P2817A BC Cormorant Road Response to RFIs

Proposed Self-Storage Units, 295 Cormorant Road, Kooragang Island, NSW

The following letter has been provided in response to items raised by the Department of Planning, Transport for NSW and City of Newcastle Council. The relevant items and response are following:

Peak Hour Vehicle Summary

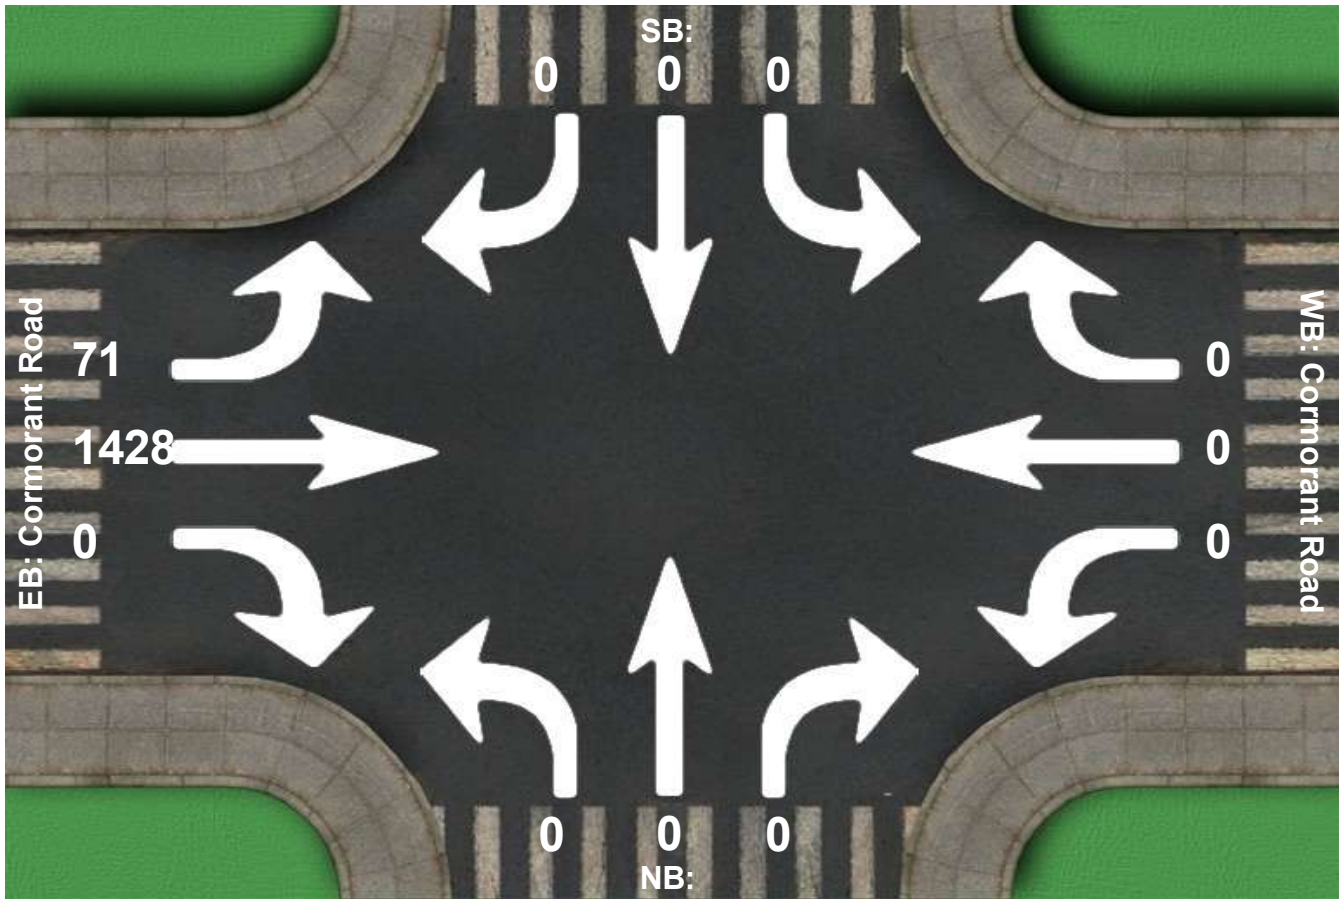
1. The proposal requires exiting vehicles from the storage unit development to utilise the hardstand area adjacent to the heavy vehicle petrol bowzers. The traffic assessment included observations of the existing service station use between 6:30 am–8:30 am and 3:30 pm–5:30 pm. However, only data for the first hour of each observation period has been provided. Please supply the traffic data for the second hour of both the AM and PM peak periods to complete the assessment.	Attachment B
